UNITED STATES  
DEPARTMENT OF THE INTERIOR  
BUREAU OF LAND MANAGEMENT

FORM APPROVED  
OMB NO. 1004-0137  
Expires: January 31, 2018**SUNDRY NOTICES AND REPORTS ON WELLS**  
**Do not use this form for proposals to drill or to re-enter an abandoned well. Use form 3160-3 (APD) for such proposals.**5. Lease Serial No.  
NMNM0405444

☒ Oil Well ☐ Gas Well ☐ Other8. Well Name and No.  
TODD 23H FED 6

**PROPOSED WELLBORE**

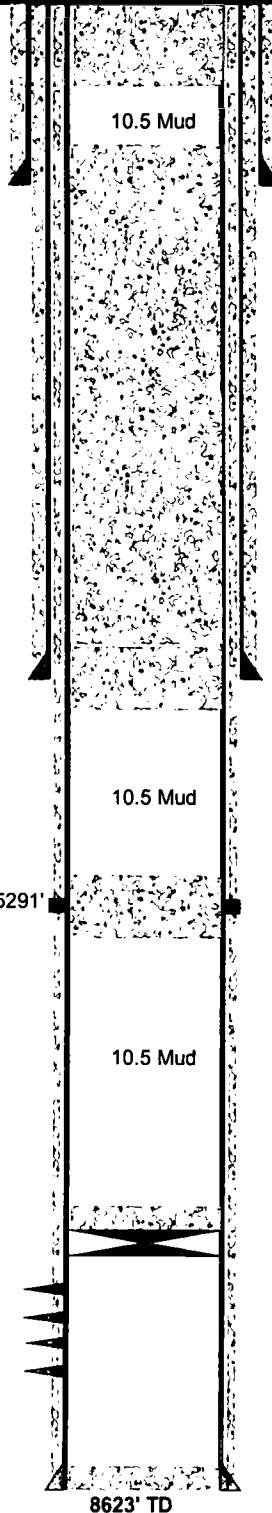
**\*\* BLM REVISED \*\* BLM REVISED \*\* BLM REVISED \*\* BLM REVISED \*\* BLM REVISED \*\***

*woc Tag*

Proposed:  
 1. Spot 310 sx (3100') CI C at 800-3900'. Tag.  
 (Solid plug across salt, shoe @ 850')

Proposed:  
 1. Spot 25 sx (250') CI C at 5166'-5416'.
